**Daniel J. MacDonald Modernization**

.1 The following Drawings are revised and re-issued with this addendum. Revisions are shown in bubbled areas on drawings. The following descriptions of revisions are for convenience only and do not define or limit the extent of actual revisions indicated on drawings:

End of NORR Addendum No. 7

Project number: R.056687.005  
drawing no.: A42-03

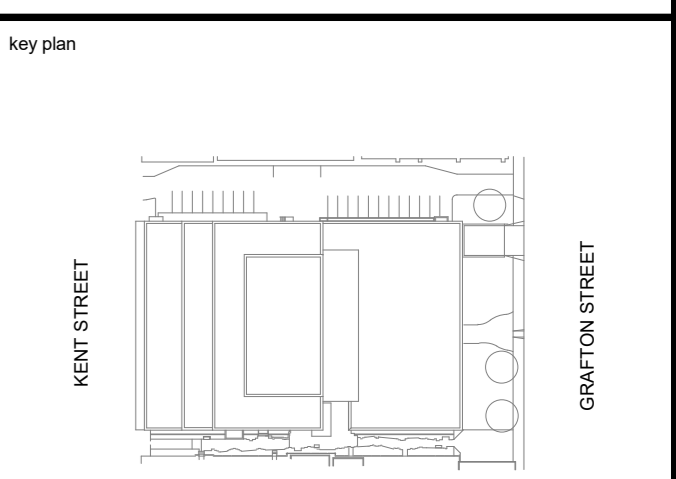
- .1 Drawing A42-03 - ATRIUM STAIR DETAILS
  - .1 Revised to show location of material PT-SPC.
- .2 Drawing M02-02 - MECHANICAL SCHEDULES 2
  - .1 Revised info in the Pumps Schedule.

Project number: R.056687.005  
Drawing no.: M53-00

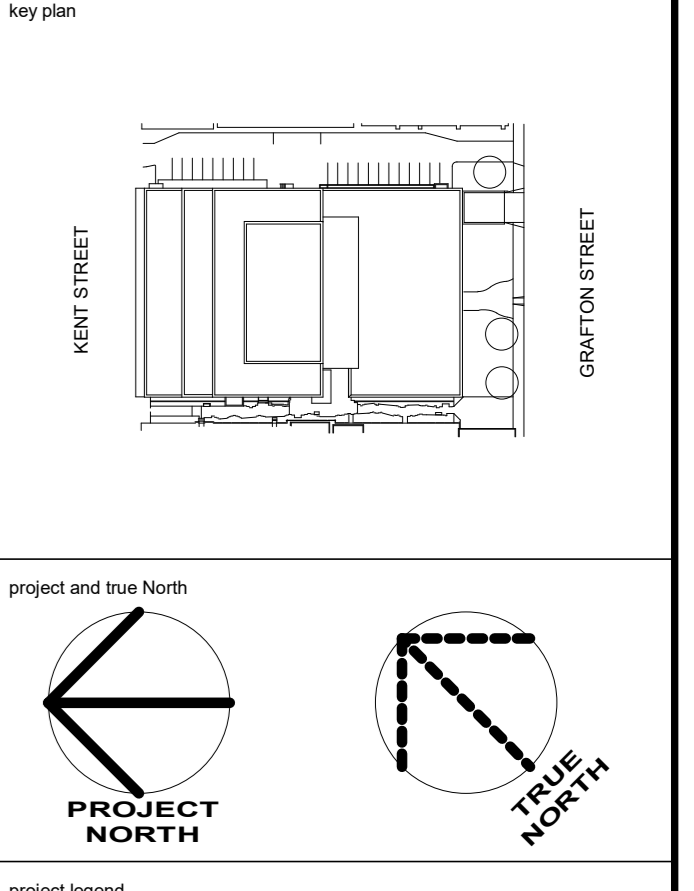
- .4 Drawing M53-00 - HYDRONIC - PARKING LEVEL NEW WORK
  - .1 Revised pipe sizes.
- .5 Drawing M53-01\_HYDRONIC - MAIN FLOOR NEW WORK
  - .1 Revised notes reflecting pipe sizes.

**1  
M53-02** HVAC PIPING SECOND FLOOR  
SCALE: 1:100

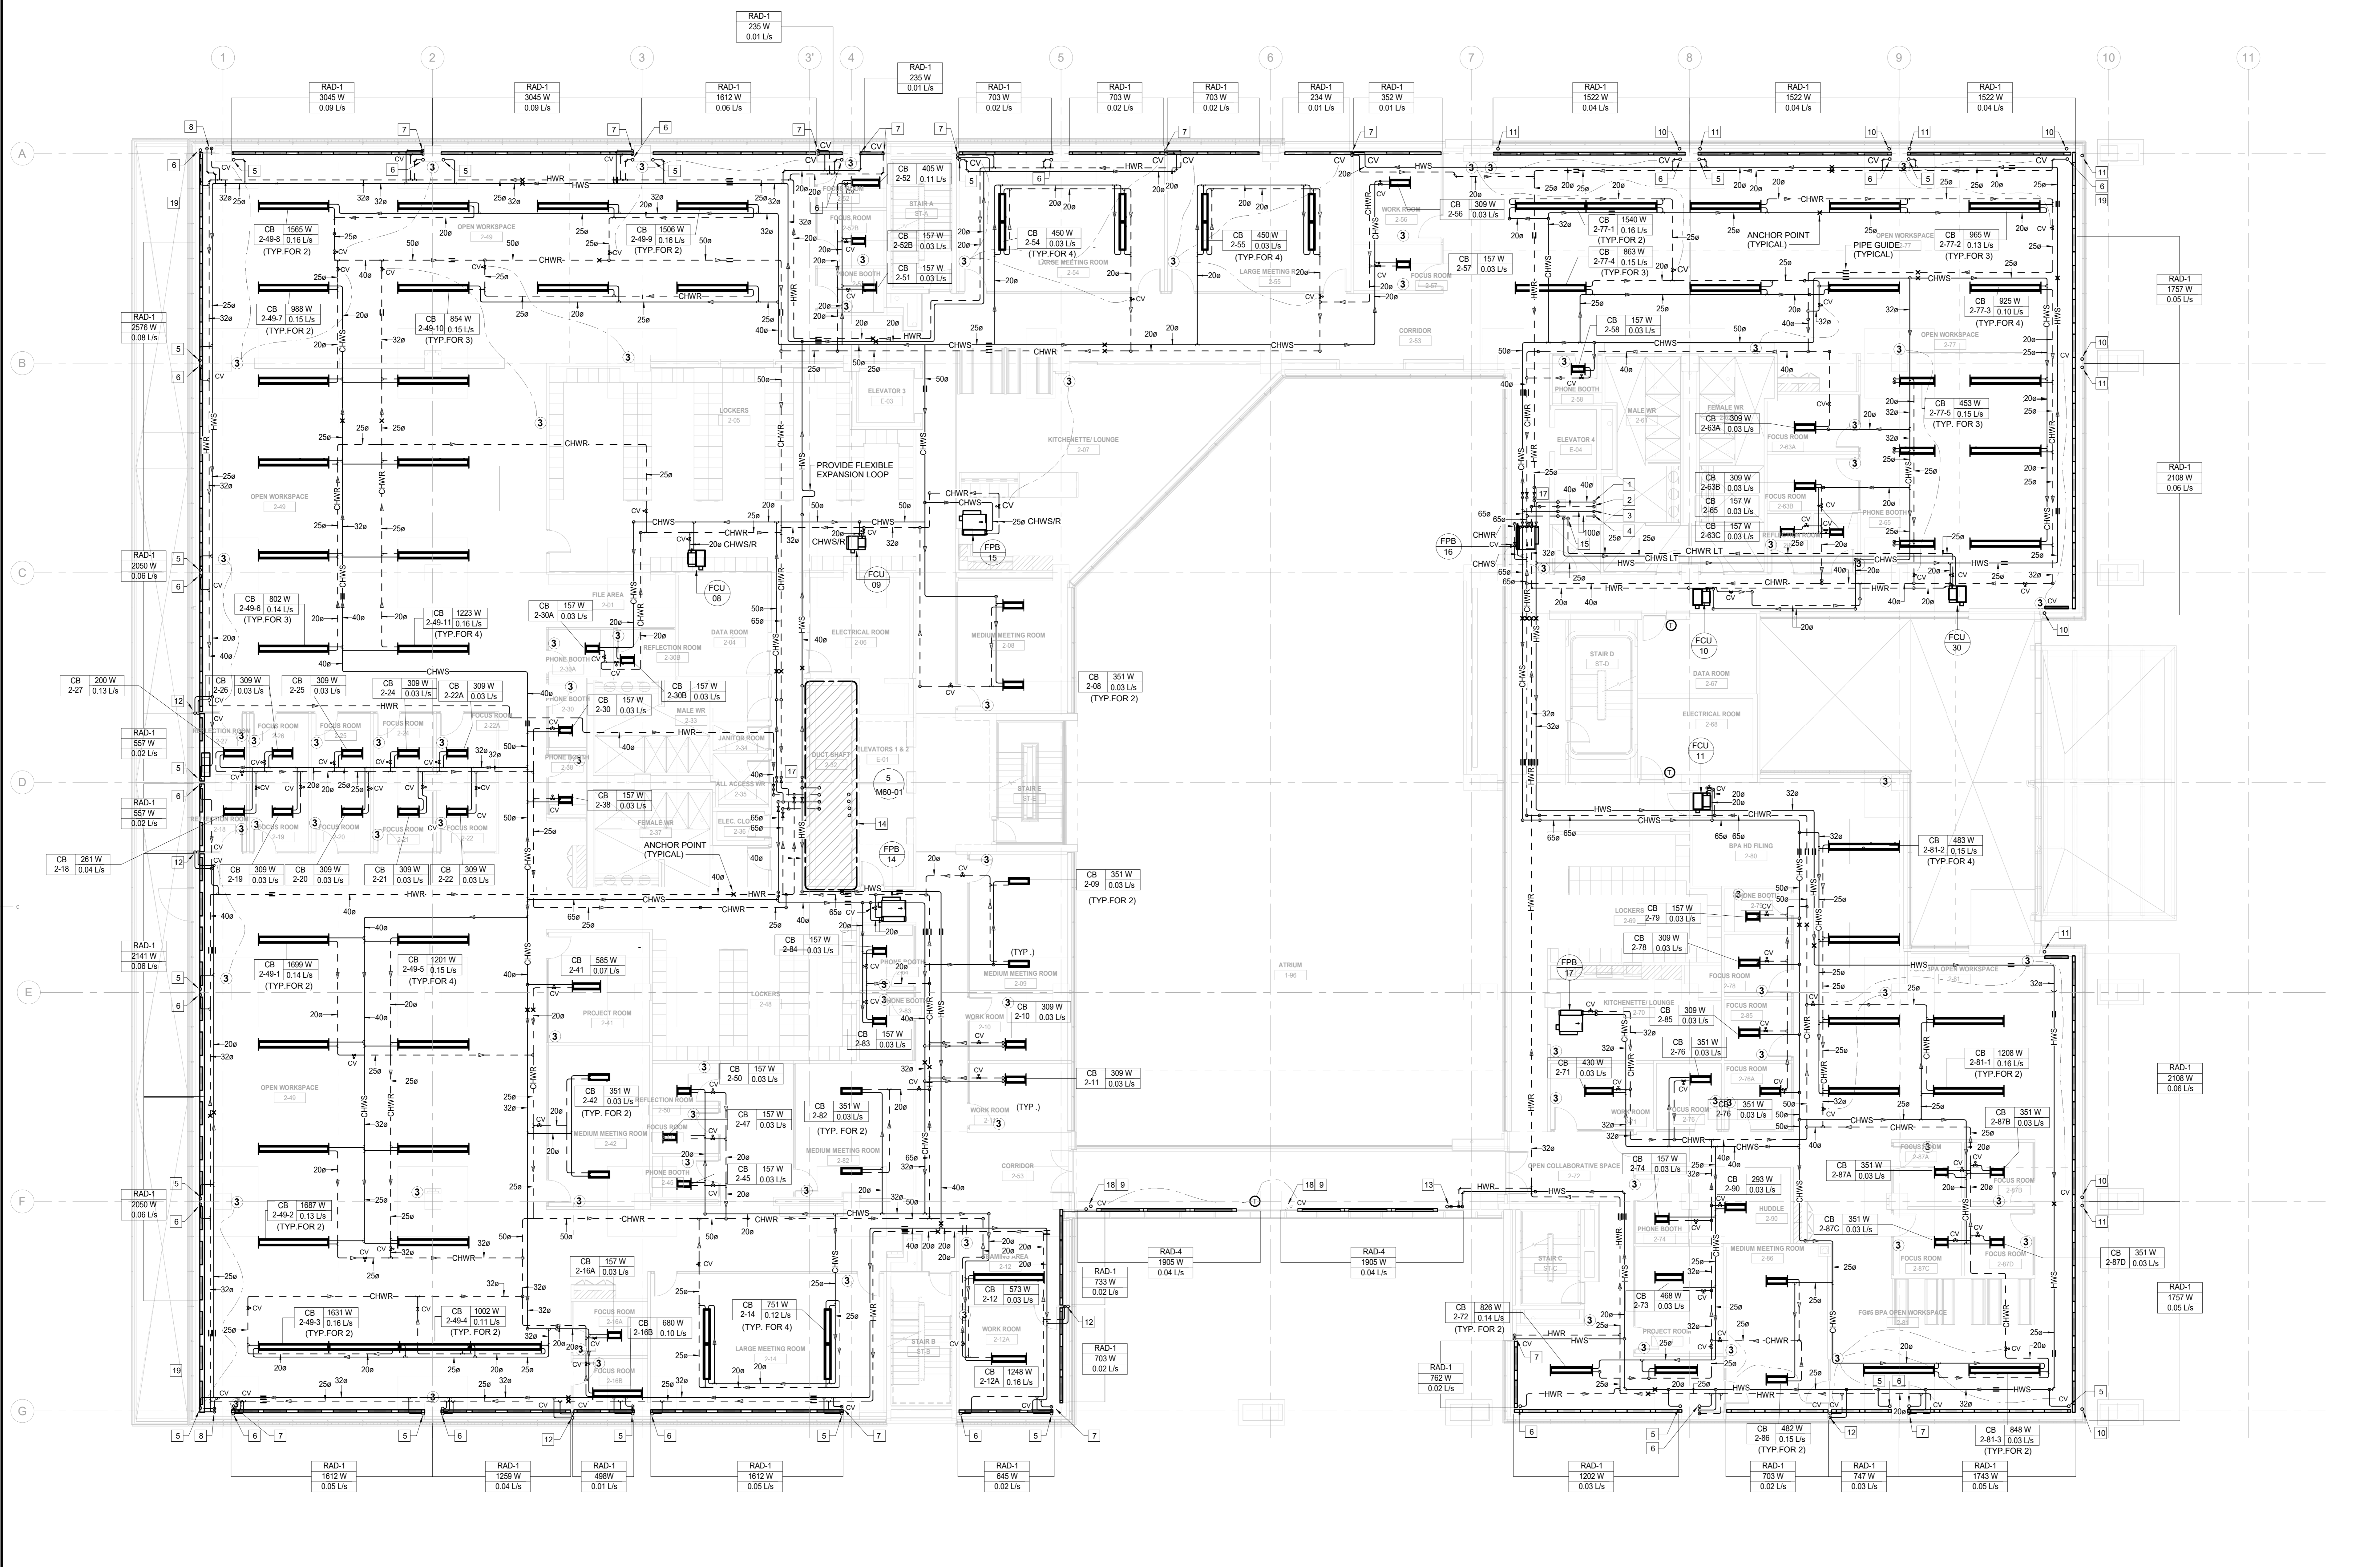
- .6 Drawing M53-02\_HYDRONIC - SECOND FLOOR NEW WORK
  - .1 Revised notes reflecting pipe sizes.
- .7 Drawing M53-03 - HYDRONIC - THIRD FLOOR NEW WORK
  - .1 Revised notes reflecting pipe sizes.

1 HVAC PIPING PENTHOUSE FLOOR  
 M53-06 SCALE: 1:100

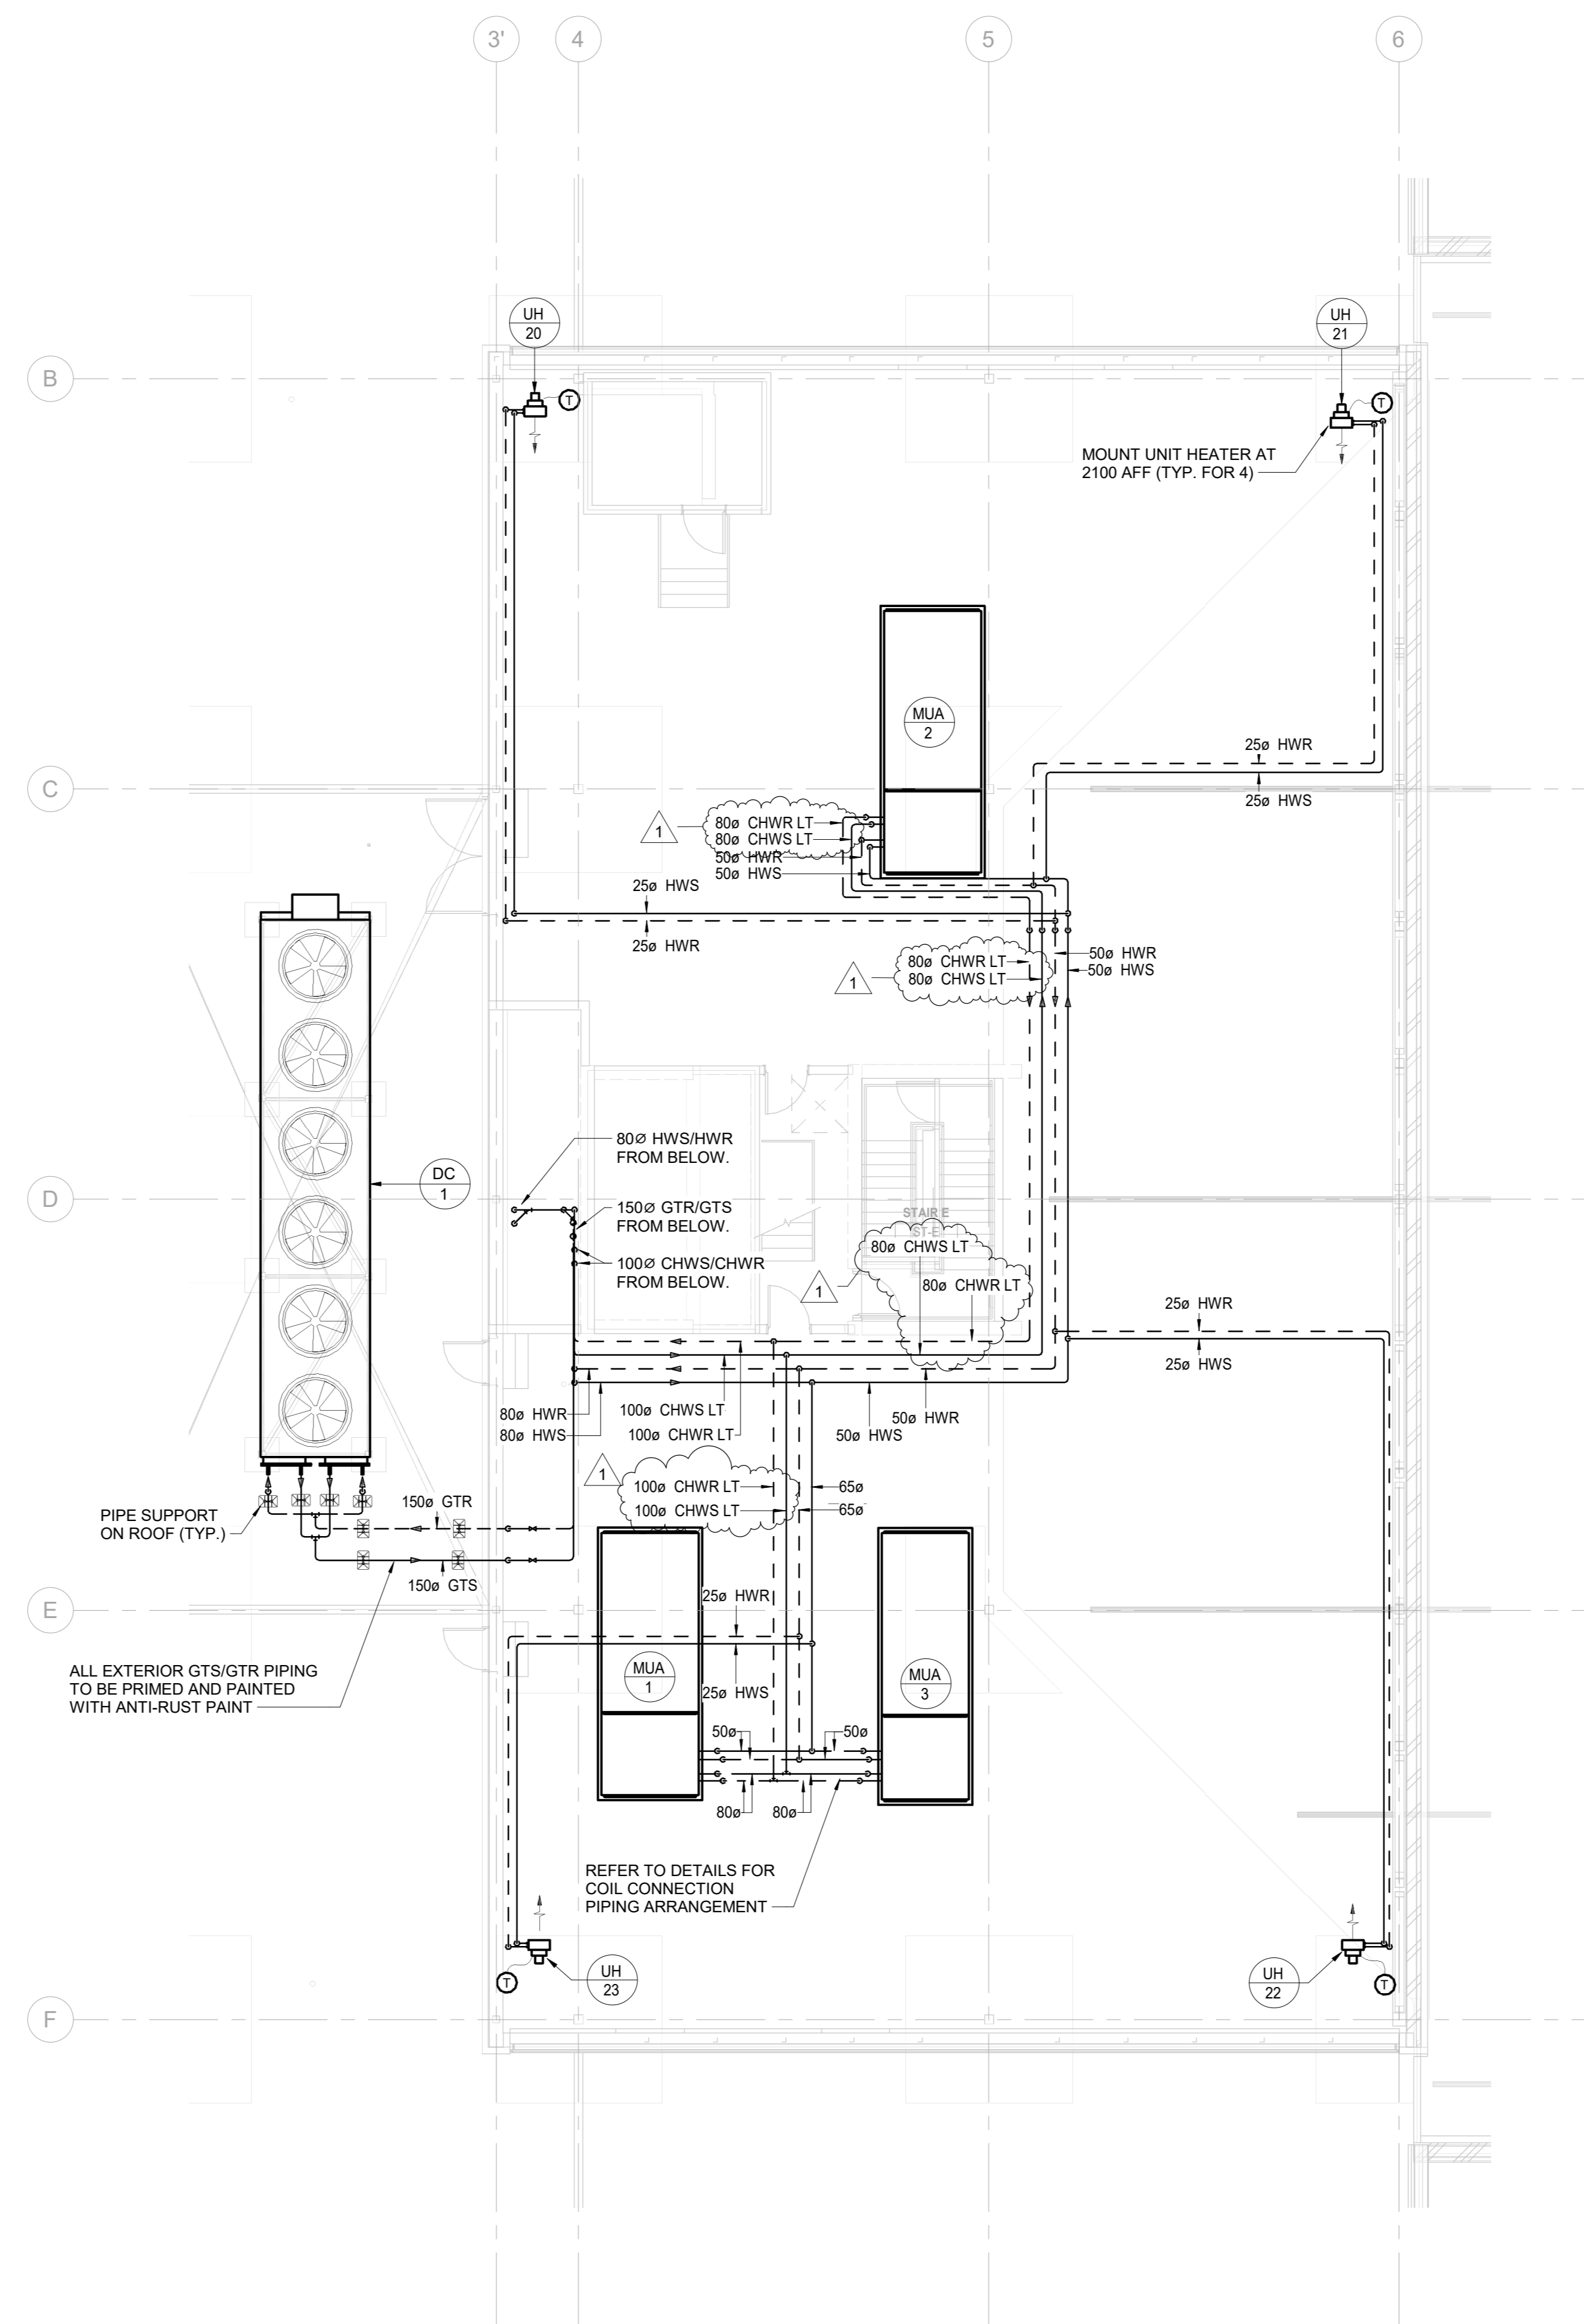
- .8 Drawing M53-06 - HYDRONIC - PENTHOUSE FLOOR NEW WORK
  - .1 Revised pipe sizes.
- .9 Drawing M60-01 - MECHANICAL RISER DETAILS PART PLANS
  - .1 Revised notes reflecting pipe sizes.
